**Planning Proposal 2017 CANAD\_005**  
**Lot 1 DP219742, 7 Concord Avenue, Concord West**  
**Response to Submissions Report – Addenda Flooding Report**

October 2020

## Response to Submissions Report – Addenda Flooding Report

Figure 1- Pre-developed Hydraulic Categories

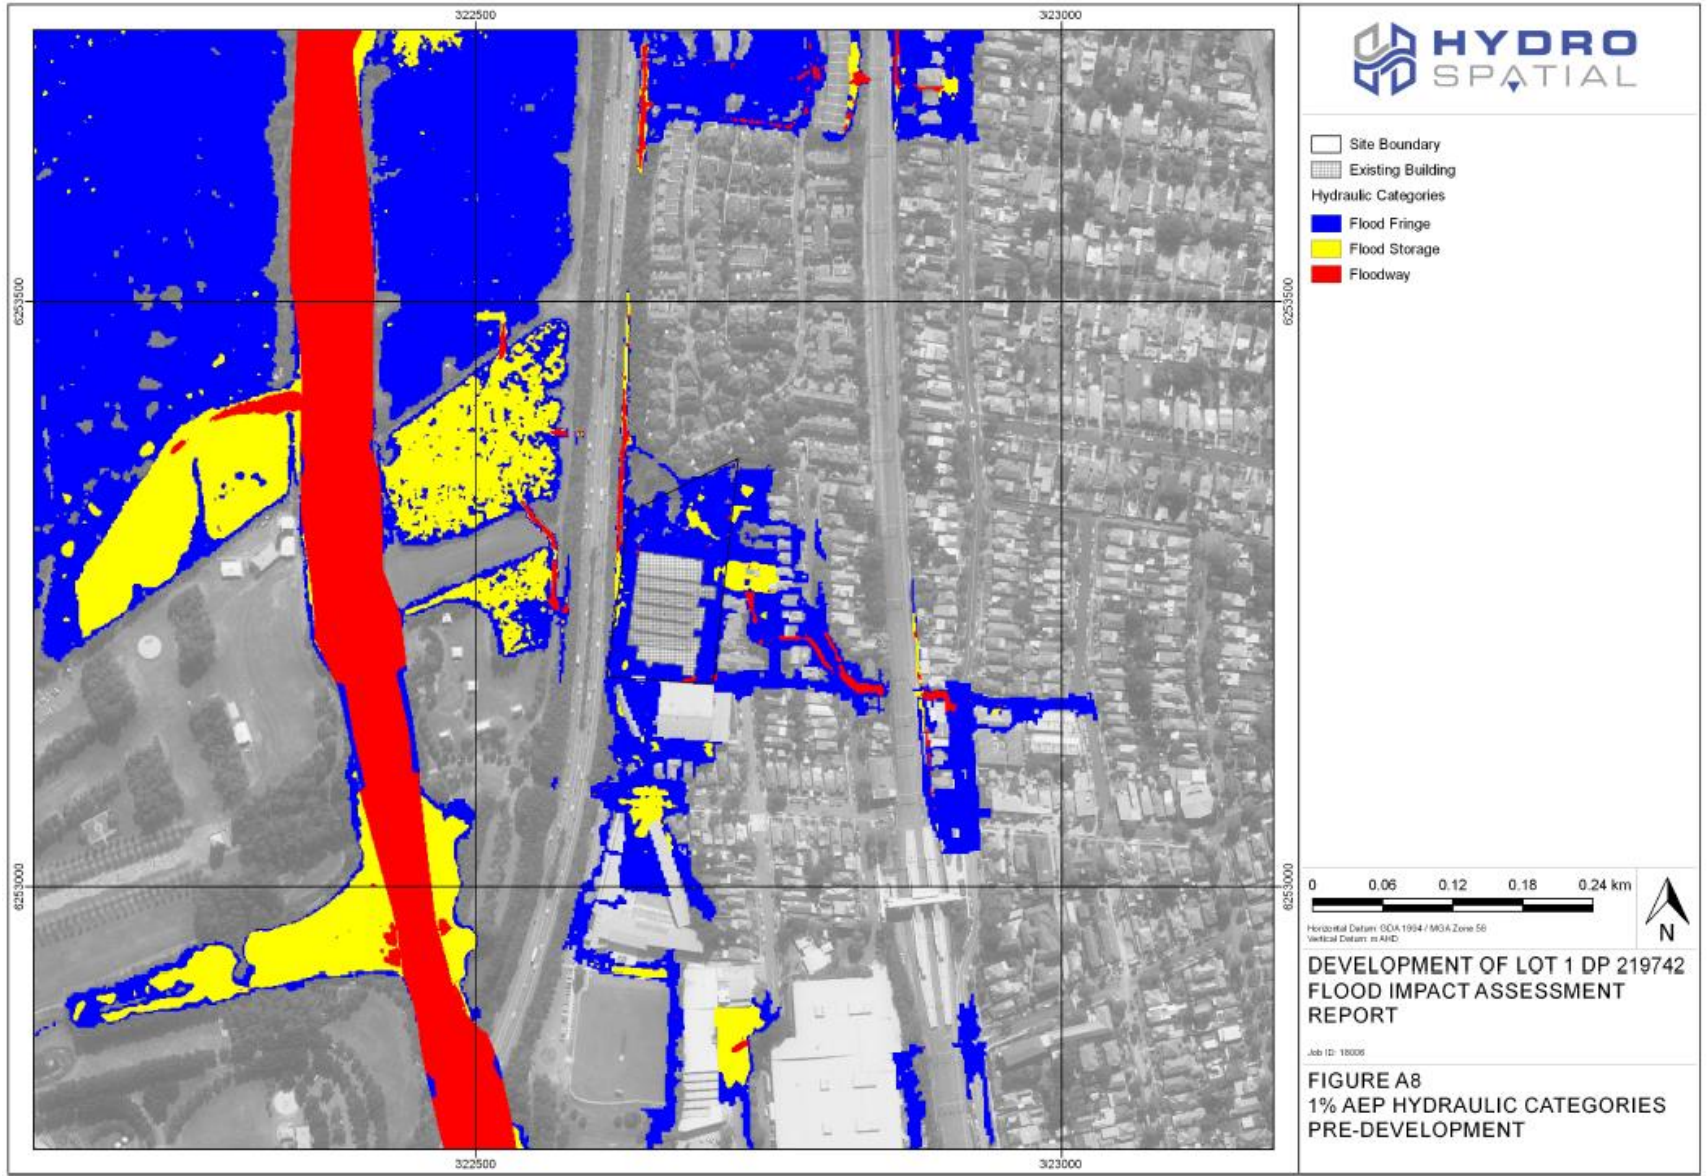
**Figure 1** above outlines the existing site conditions and the hydraulic categories, including any floodways, through the site. There are no floodways on the existing site.

Figure 2 - Post developed (including Option 2) Hydraulic Categories

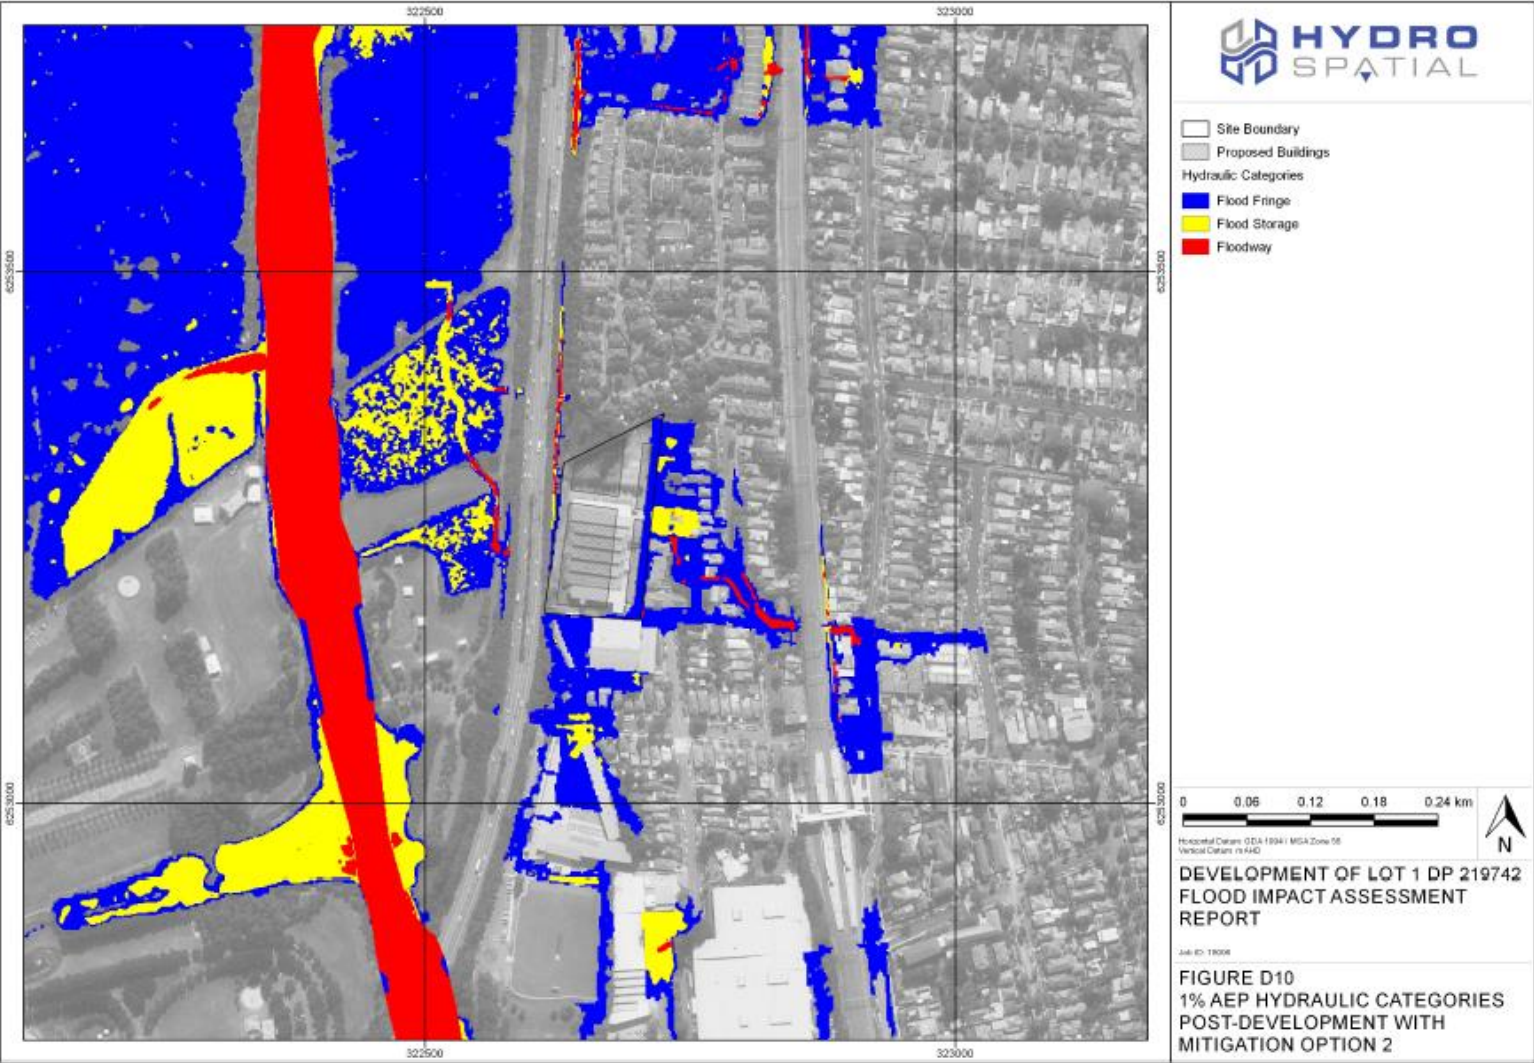
The proposed development alters the existing footprint of the built components on the site and includes mitigation option 2, which takes into account a 50% blockage factor through the main flow conveyance systems. **Figure 2** outlines the post developed hydraulic categories, including any floodways, through the developed site. There are no floodways on the post developed site.

**Figure 3 - 1% AEP flood level impact - Post developed including mitigation option 2.**

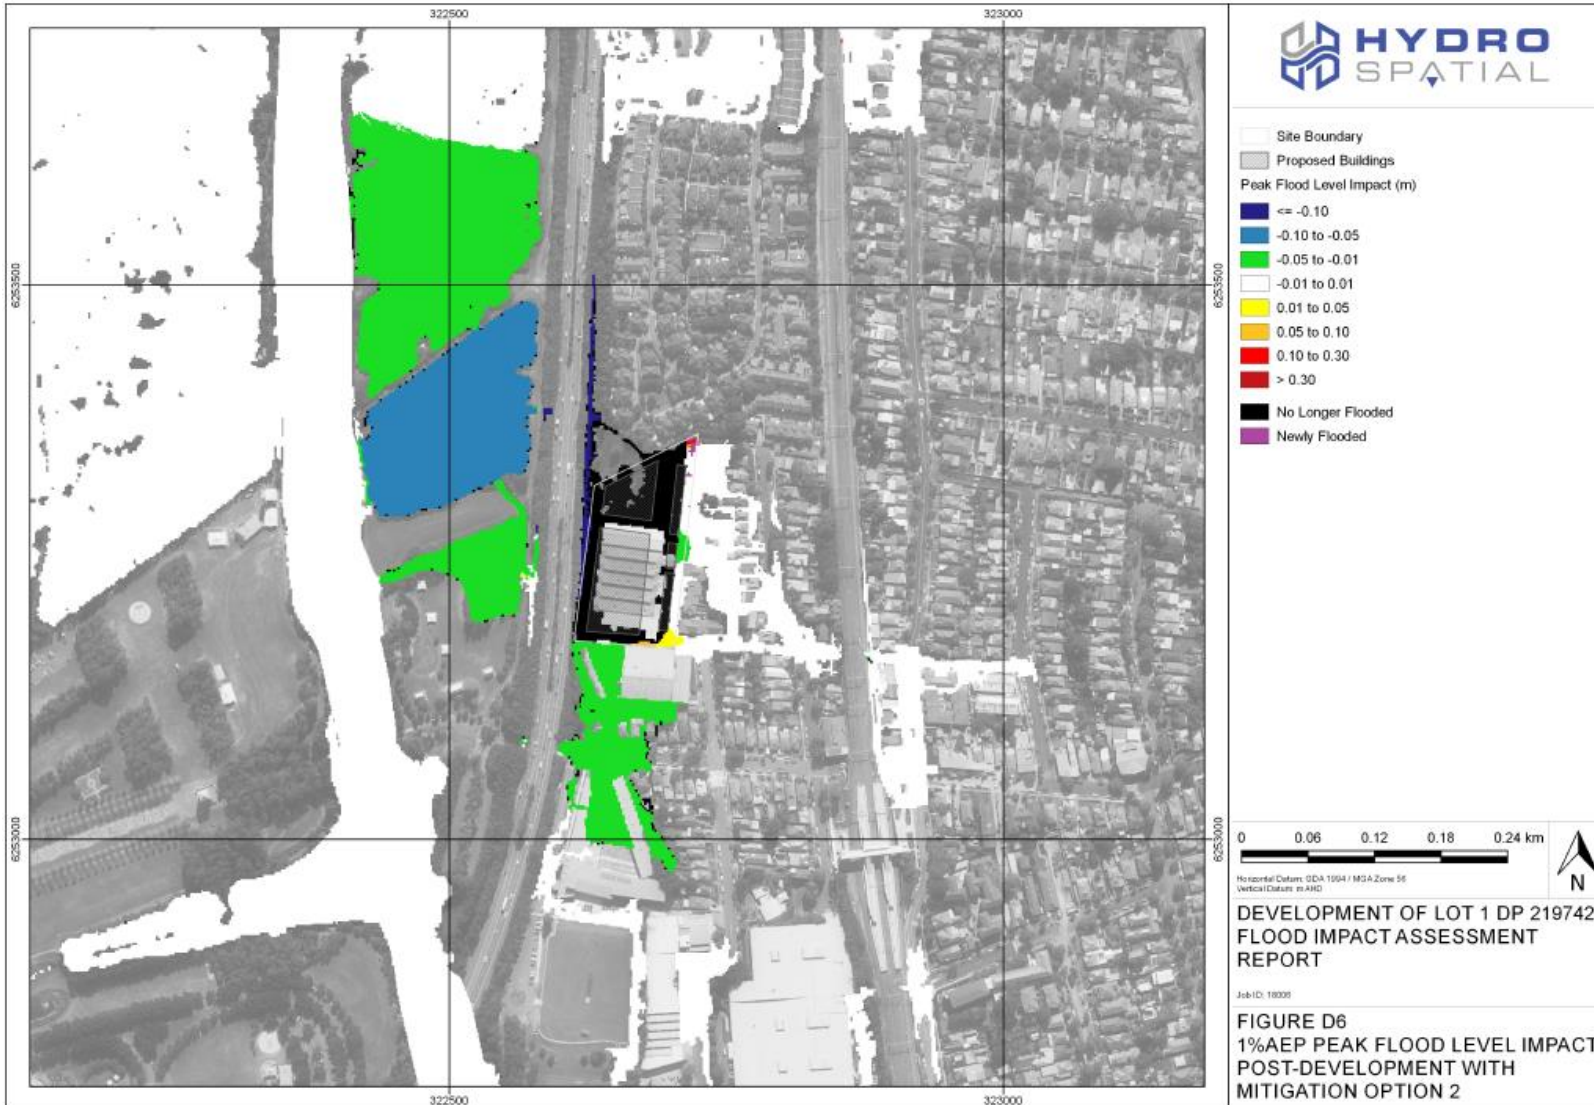
**Figure 3** outlines the impact during the 1% AEP design flood event of the development when mitigation option 2 is included.

**Figure 3** represents the post developed flood level impacts for the 1% AEP design flood event in open areas (note the flooding in the void is not shown), with mitigation option 2 included in the development. This indicates that there is no increase in flood levels caused by the alteration to the flood flows on the development site. Small reduction in flood levels of up to 0.05 metres (5cm) are predicted to occur across the neighbouring properties during the 1% AEP design flood event. In addition, it also indicates that the implementation of Option 2

would not result in the redistribution of flood flow outside of the site, even with 50% blockage of the inlet opening.

Figure 4 Water Level Hydrograph for the D/S end of the Northern Culvert for the 1% AEP flood

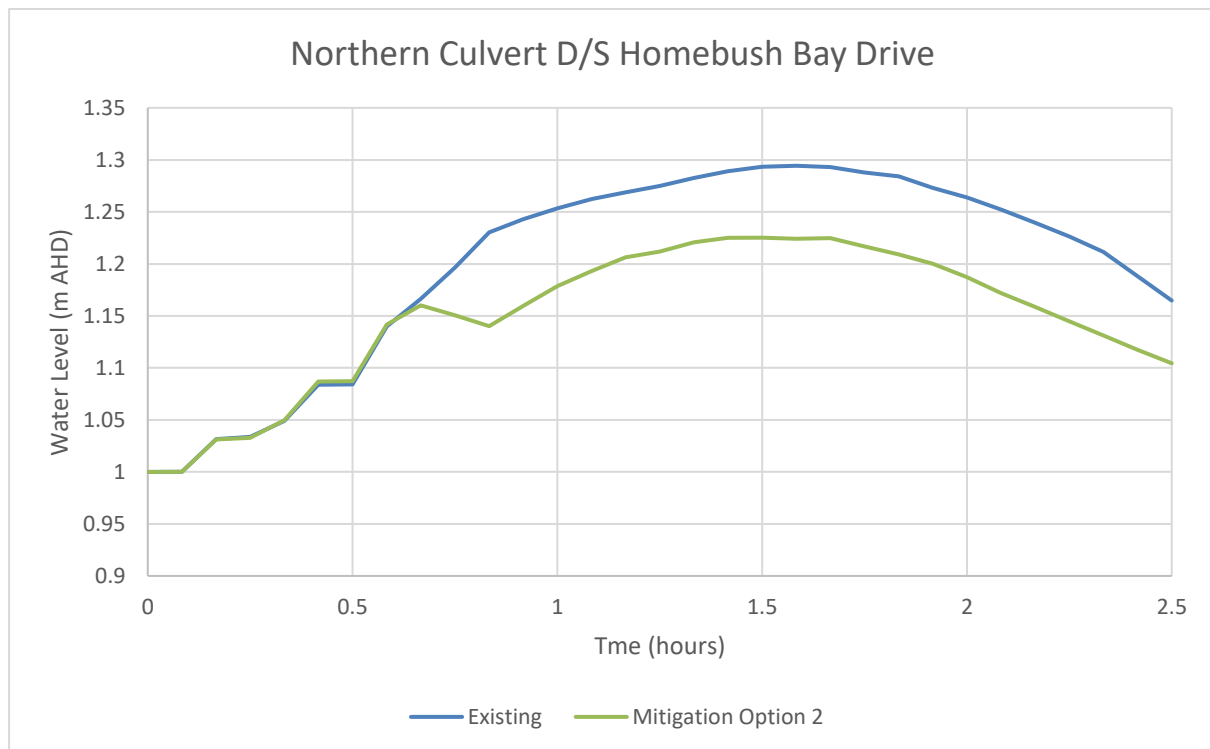
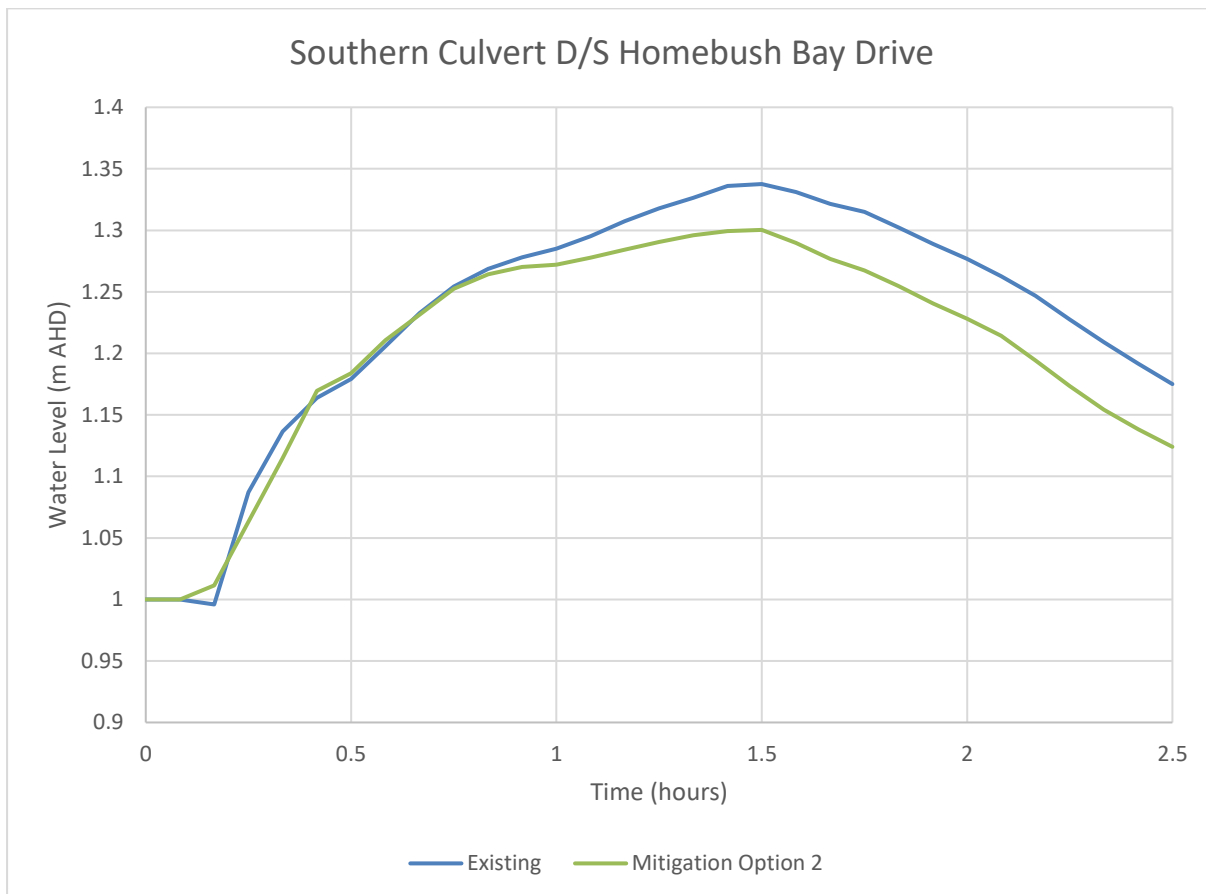
The Department (Department of Planning, Industry and Environment) has raised concerns that the development may impact the two existing pipe culverts (that outlet as box culverts) beneath Homebush Bay Drive. Council have also raised concerns around this as they believe the culverts are poorly maintained.

The existing downstream pipe culverts have been included in the flood models and their impacts on flood levels on the subject site are incorporated into the flood assessments. The proposed development will lower the peak flow rates entering the culverts thereby reducing their impact on flood levels. Also, the proposed development minimum floor levels have a 1m freeboard to the 1% AEP flood levels (which is 0.5m above the FDM 2005 requirements) to accommodate variations in flood levels.

Analysis of the Jacobs model suggests that the catchment draining to the culverts is at least 49.7% impervious, although this only includes roads and buildings and not other impervious areas such as driveways and concreted yards. The development will cause an increase in the impermeable area of only 1.1% in the catchment. Therefore, the development will generate an insignificant amount of additional volume that flows into these culverts.

The proposed development also controls the floodwaters that arrive on site and directs them into the proposed void. This has an attenuating affect which reduces the flood peaks through the Homebush Bay Drive culverts downstream, therefore having a net positive impact on the culverts. This is shown in Figure 4 and Figure 5 for the northern and southern culverts respectively, where water levels downstream are reduced form existing levels.
